INVITATION TO BIDDERS #2026-02
CAMPUS ELECTRICAL DISTRIBUTION
RESPONSE TO CLARIFYING QUESTIONS II
February 23, 2026

1
C1.1
PROPOSED SITE PLAN
1" = 5'

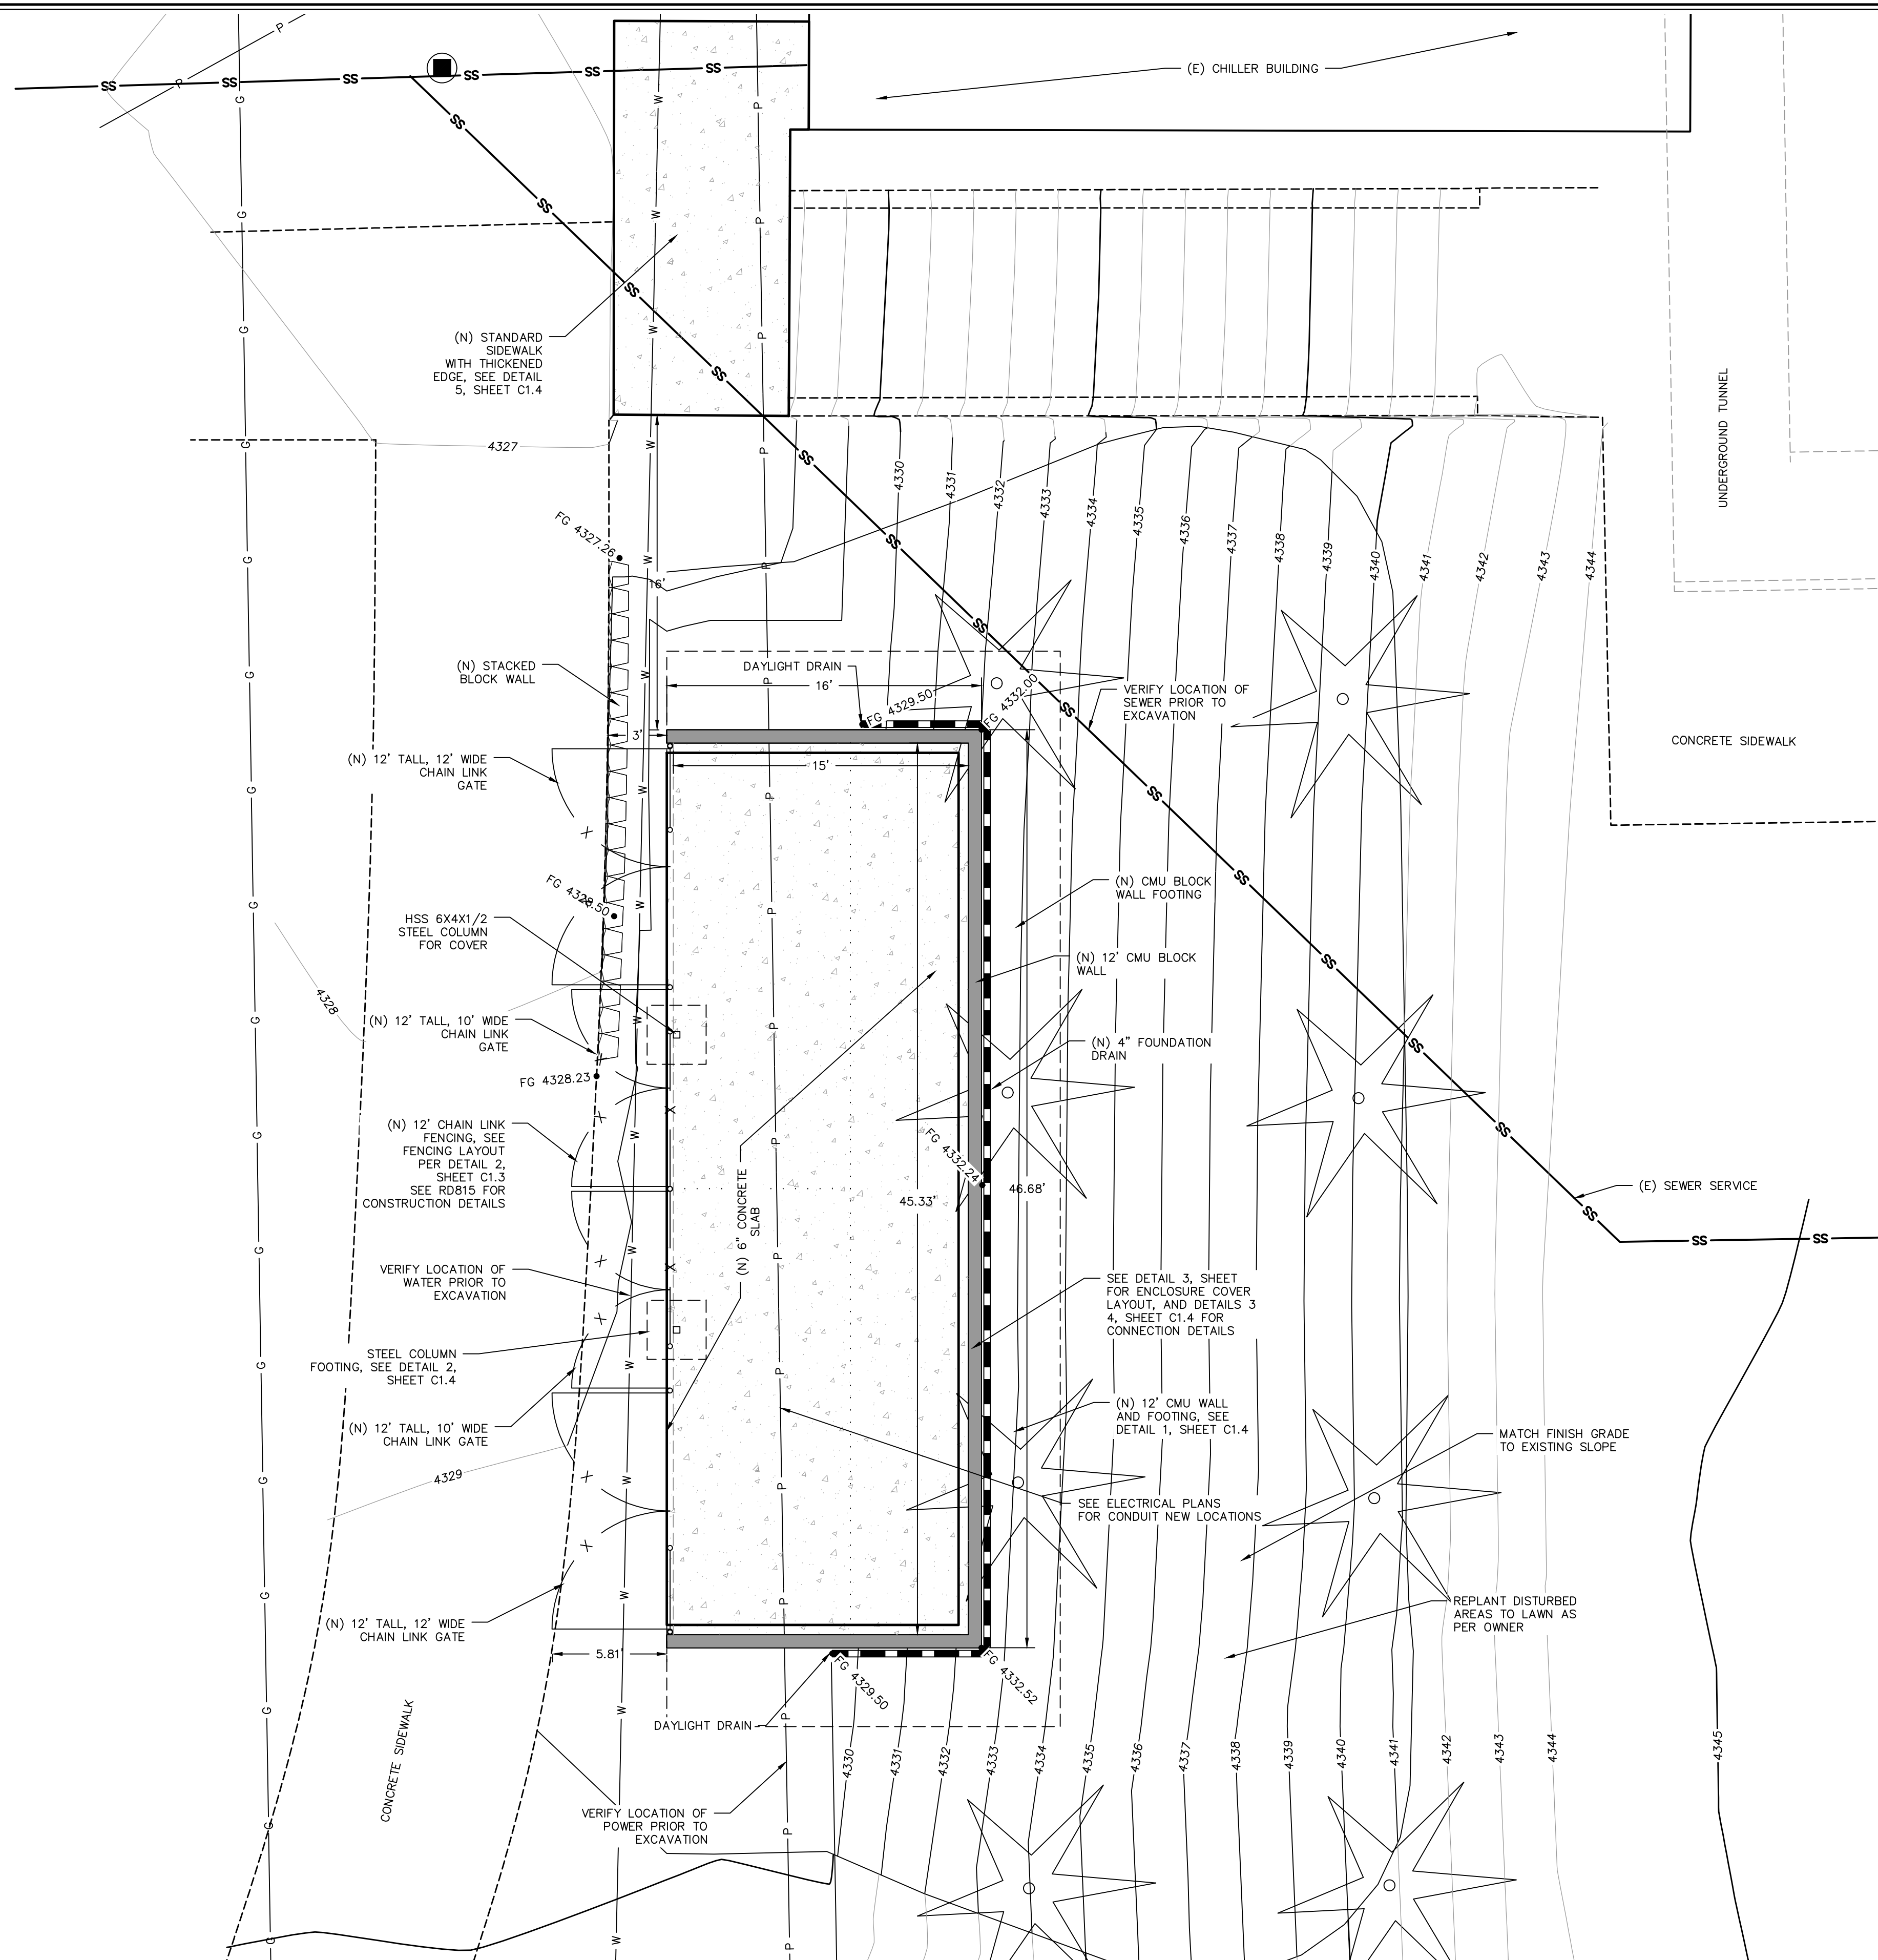
8. **QUESTION: Tree Removal Count and Landscape Restoration Responsibility**

Please confirm the quantity of trees to be removed (plan callout not shown) and whether stump grinding/root removal is required. Also please confirm who is responsible for landscape restoration (topsoil, seed/sod, irrigation repairs, shrubs/trees) in areas disturbed by trenching and restoration work. Contractor scope vs. OIT Maintenance.

ANSWER: Trees will need to be removed. See the attached drawing. Contractor responsible for final grading with topsoil around switchgear pad. Seeding by the owner,

on the slope areas around the pad. Replace damaged grass in irrigated areas with sod. Repair any damaged irrigation lines.
